21154 PCI-to-PCI Bridge

Specification Update

July 2004

Figure 1. S_Clock Multiplexer Workaround Circuit for Errata 6.

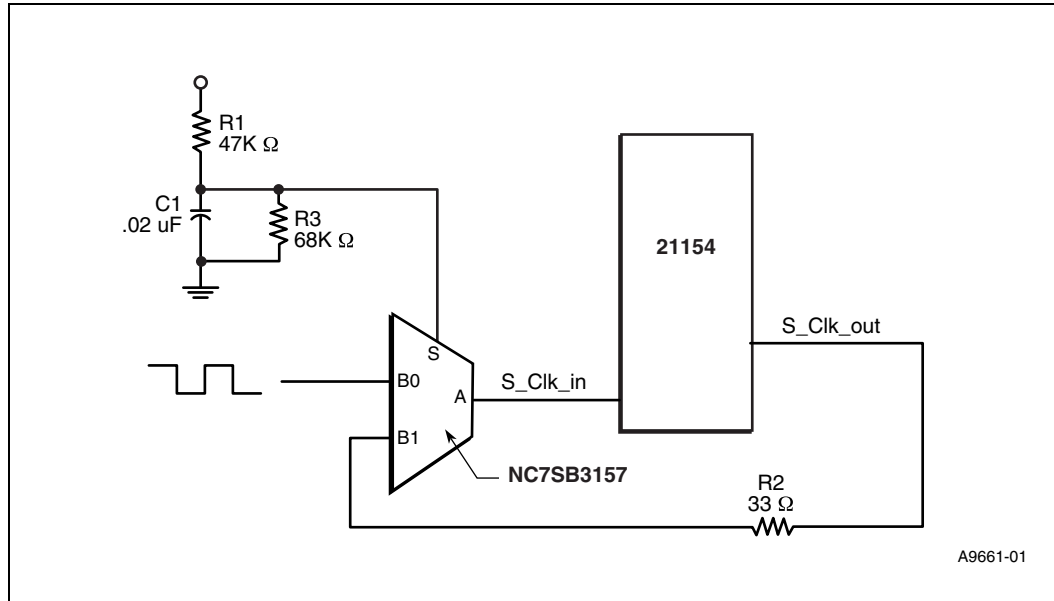
1. [Figure 1](#) illustrates the first recommendation - a circuit where an on-board pulse source is gated via the B0 input of the multiplexer to the S_Clock_in pin of the 21150.

At time 0, the S input of the multiplexer is low, allowing pulses from the on-board pulse source, connected to the B0 input, to be provided to the 21150 S_Clk input pin. When the time determined by the R/C network is satisfied, the S input pin will be in a logic High state. The multiplexer will then shut off the input pulse from S0 and will direct the S_Clock_out pulses via the B1 multiplexer input, into S_Clock_in

The values used for the R/C network should be selected to allow a minimum of 2 pulses to be delivered to the 21150 after Vdd has reached 3.0V at a frequency not to exceed the appropriate PCI component. i.e. 30 ns for a 33Mhz bridge. These values should be chosen based on the rise time of the power supply and the frequency of the on board pulse source. The values given for R1, R3, and C1 are for example purposes only.

Note: The NC7SB3157 2:1 Multiplexer / Demultiplexer Bus Switch used in this example has a maximum propagation delay of 800ps that should be taken into consideration when matching trace lengths of the clock lines to avoid introducing excessive skew in the clocks. All S_Clock etch lengths must be matched to within 2ns @ 33Mhz or 1ns @ 66Mhz. The addition of this circuit requires that the etch length for the S_clock_in signal be reduced to compensate for the 800ps delay.

Figure 2. Recommended Circuit for a Tristable Buffer

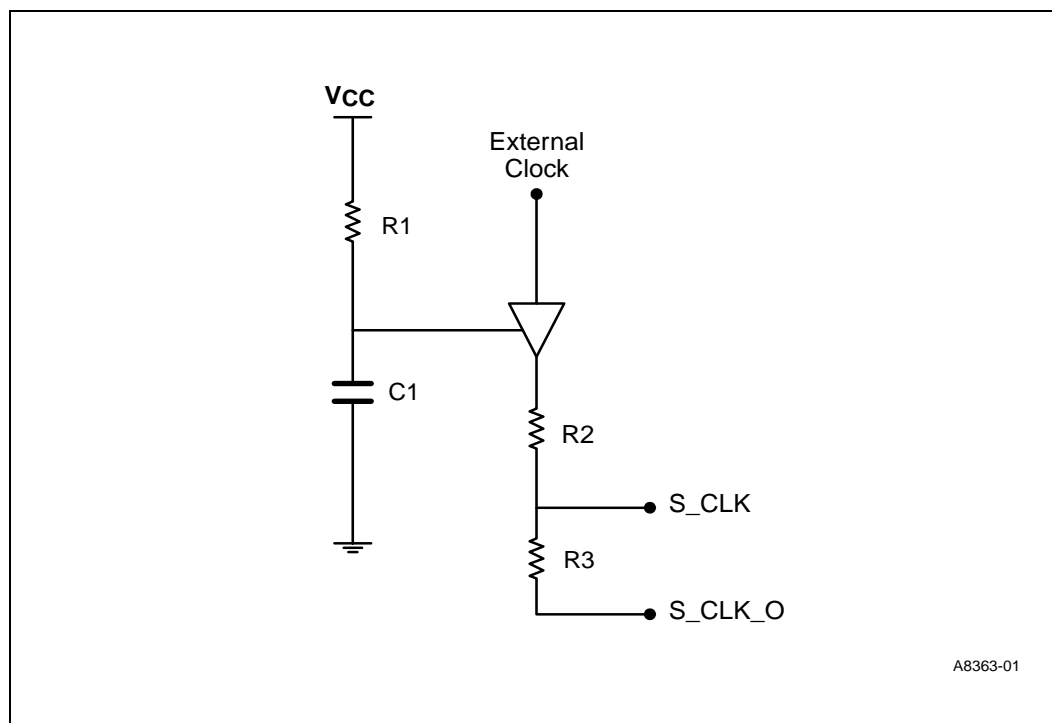
2. In the second recommendation, to guarantee the proper initialization of the **s_clk** circuits, the addition of an external circuit that provides a minimum of two transitions on the **s_clk** input during the power-up ramp is necessary. This can be done using a solution that drives an external clock onto the **s_clk** input while 3.3V Vcc is ramping during power up.

Figure 2 illustrates the use of a tristable buffer to provide multiple pulses to the **s_clk** input. The Vcc ramp rate and R1,C1 time constant determine the duration and amplitude of the pulses generated during power up. The R2-R3 values are chosen based on applicable board etch impedance-matching requirements.

The following should be considered in calculating the R1,C1 time constant:

- Make the time constant of the circuit as short as possible, while still ensuring that a minimum of two pulses are generated during the Vcc ramp.
- Phase delay between **s_clk_o** and the external clock should be minimized.
- Matching the external clock and **s_clk_o** frequencies to reduce contention.
- Laboratory experiments using **p_clk** as the external clock and a R1C1 time constant between 40 and 60 percent of the Vcc ramp have been successful using this configuration. However the use of **p_clk** as the external clock violates the PCI bus specification for loading of the primary clock.

Figure 6. Removal of Pull-Down Resistor for JTAG Testing

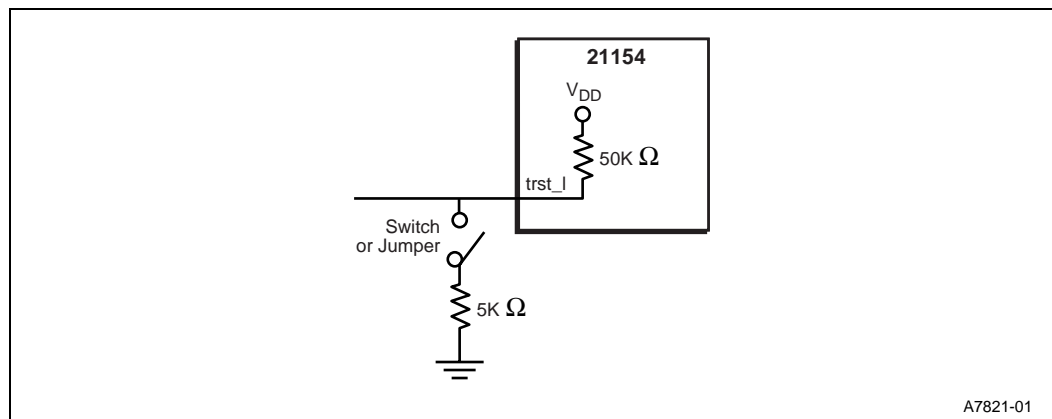
9. Section 6.3.1, Signal trst_l Pull-Down Resistor, New Section

A 5 K Ω pull-down resistor is required on trst_l for normal PCI-to-PCI bridge operation. However, some JTAG test results may be inconclusive if the 5 K Ω resistor remains in the circuit. To obtain accurate JTAG results, Intel recommends one of the following solutions:

- Verify that the JTAG test equipment, after driving trst_l low to reset the TAP controller, constantly drives trst_l high during JTAG tests. If this signal is not constantly driven high, the 5 K Ω resistor will pull the signal to a low state.
- Remove the 5 K Ω resistor during JTAG tests. This resistor must be installed during normal PCI-to-PCI bridge operation.
- Design external circuits with a switch or jumper to isolate the 5 K Ω resistor during JTAG tests (see Figure 6). This switch must enable the resistor during normal PCI-to-PCI bridge operation.

Figure 19 Example of GPIO Clock Mask Implementation on the System Board

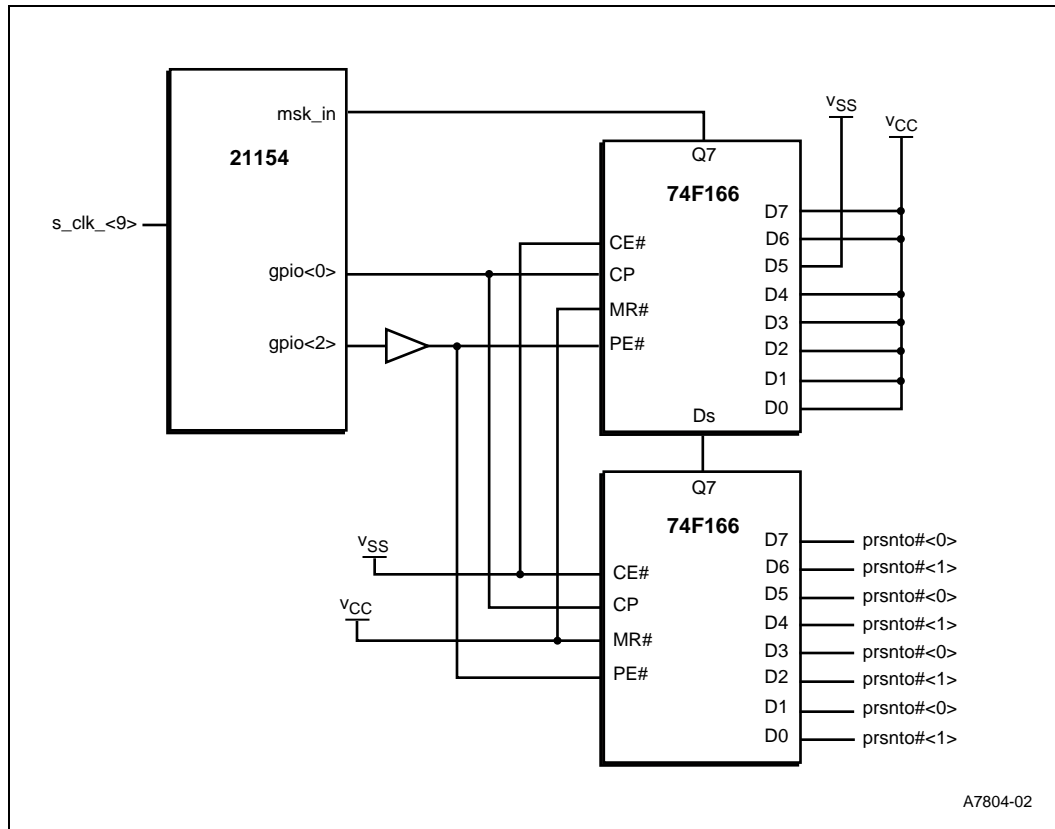
12. Section 10.2, Secondary Clock Control, Figure 19

This figure now appears as follows:

Figure 20. Clock Mask and Load Shift Timing

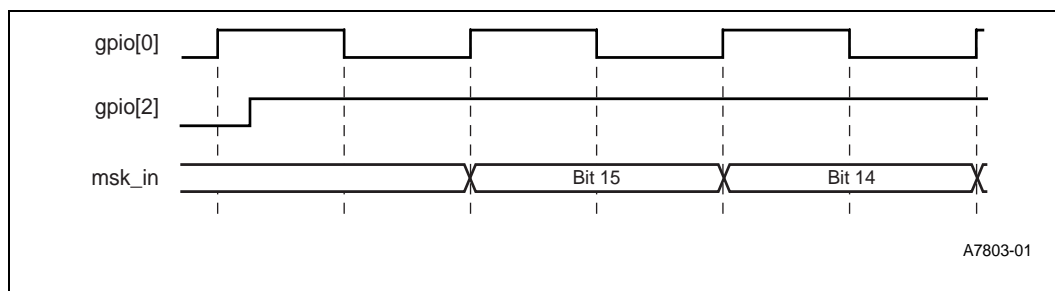
13. Section 10.2, Secondary Clock Control, Figure 20

This figure now appears as follows:

Figure 21. Clock Mask and Load Shift Timing

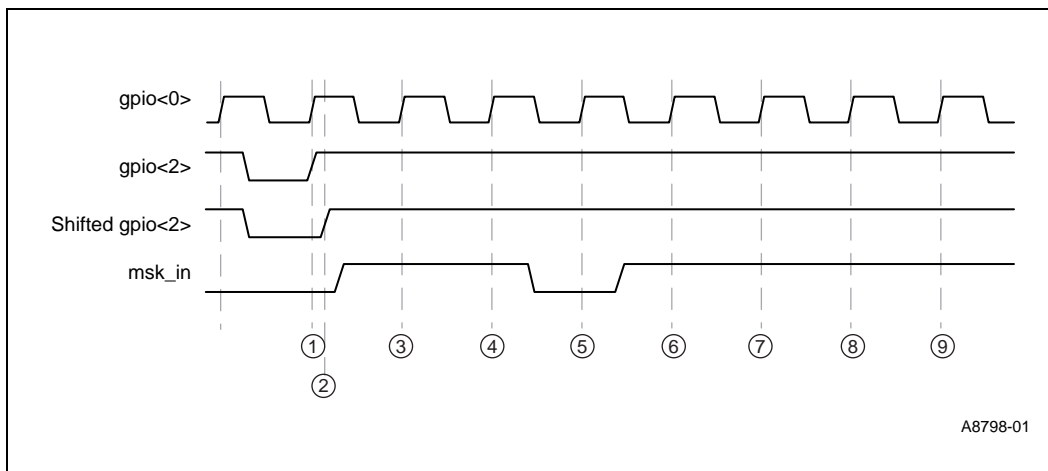
15. Section 10.2.1, Mask and Load Shift Timing Events for 66 MHz Operation

The following list provides the timing sequence for 66 MHz operation for an example circuit as shown in [Figure 19](#) and the timing diagram in [Figure 21](#).

1. The **gpio<2>** original coming from the 21154 does not provide 3ns setup time needed to provide the parallel load enable **PE#** of the 74F166.
2. The shifted **gpio<2>** is delayed by ~9ns to provide ample setup time to enable the parallel of the shift register connected to pin 15 of the 74F166.
3. Bit 15 input **D6** of the shift register is pulled high, to Vcc.
4. Bit 14 input **D7** is pulled high, to Vcc. These signals are not used internally in the 21154.
5. Bit **13 s_clk_o<9>** is a feedback to the 21154 **s_clk_o** input. To enable **s_clk_o<9>** in all cases the **D5** input of the shift register is grounded, to Vss.
6. Bit 12 **s_clk_o<8>** is disabled.
7. Bit 11 **s_clk_o<7>** is disabled.
8. Bit 10 **s_clk_o<6>** is disabled.
9. Bit 9 **s_clk_o<5>** is disabled.

Figure 3 Example of GPIO Clock Mask Implementation on the System Board

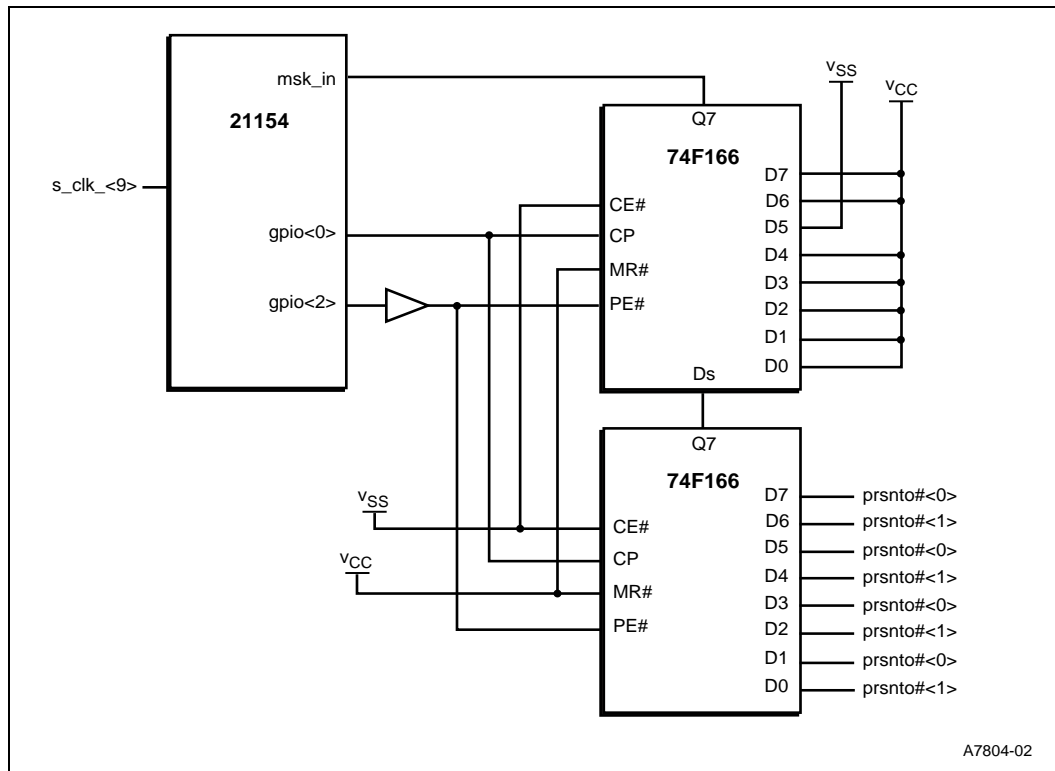
18. Section 4.4.1, Serial Clock Mask Shift, Figure 3

Figure 3 has been updated as follows:

Figure 4. Clock Mask Load and Shift Timing

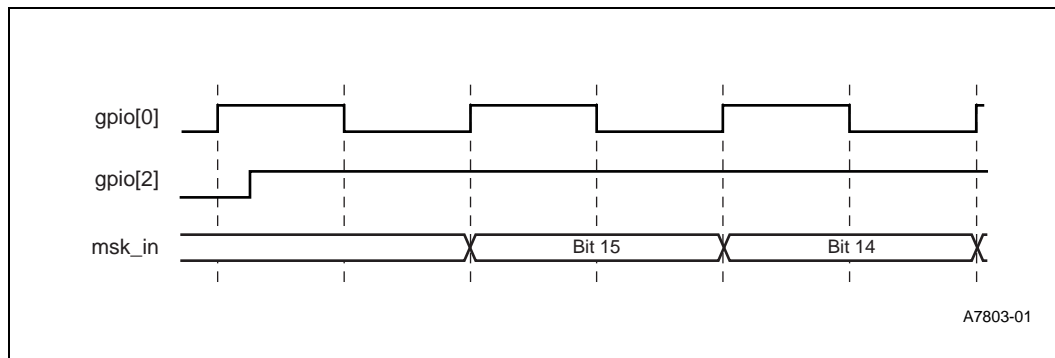
19. Section 4.4.1, Serial Clock Mask Shift, Figure 4

Figure 4 now appears as follows:
